Teven Quarry Water Management Plan

Holcim Australia March 2022 Update

Teven Quarry Water Management Review Figure 2

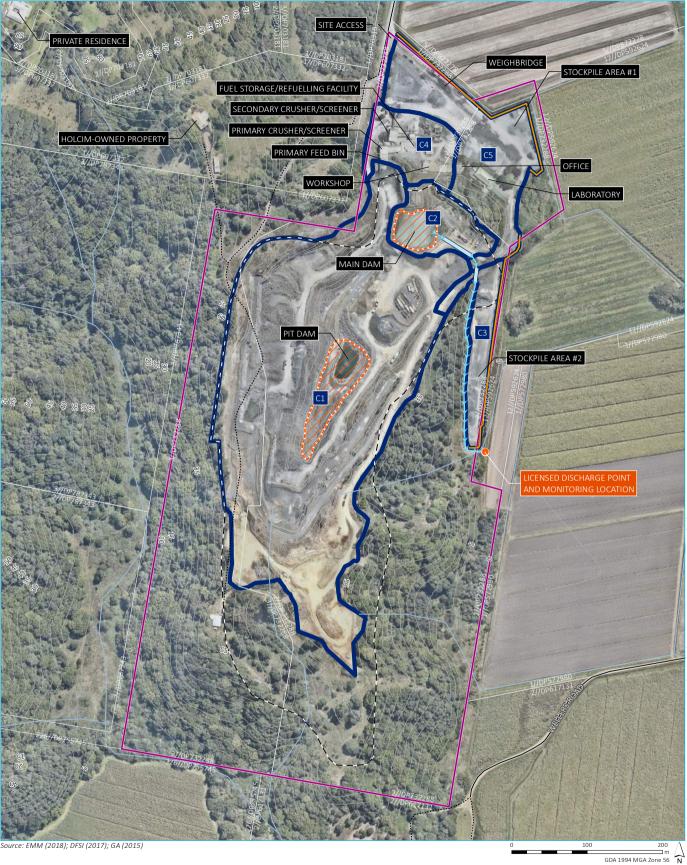
DPIE - Preliminary Comments	Holcim Response
 Section 4 Table 6, update maximum pH data error. Review discharge points in Section 4 tables. Water balance needs updating. Remove Section 5.2.1 Show wedge pits on Figure 2? Spelling potable water not portable water. Formerly rather than formally Check EPL references/numbers are correct. Table 18 - Update site name. Confirmation from secretary consultation isn't required, show an attempt of consultation (including a follow up). 	 Addressed, correct data brought in from the 2019 Annual Review. Explanation around discharge monitoring. Minor update of water balance based on dust suppression and processing demand volumes. Addition of wording around water balance updates and link to PRP recommendations (Table 4). Removed. Holcim believe this is not required as the wedge pits are included on Figure 3. Addressed. Addressed. Addressed. Addressed. To be discussed with DPIE following formal review of this plan.
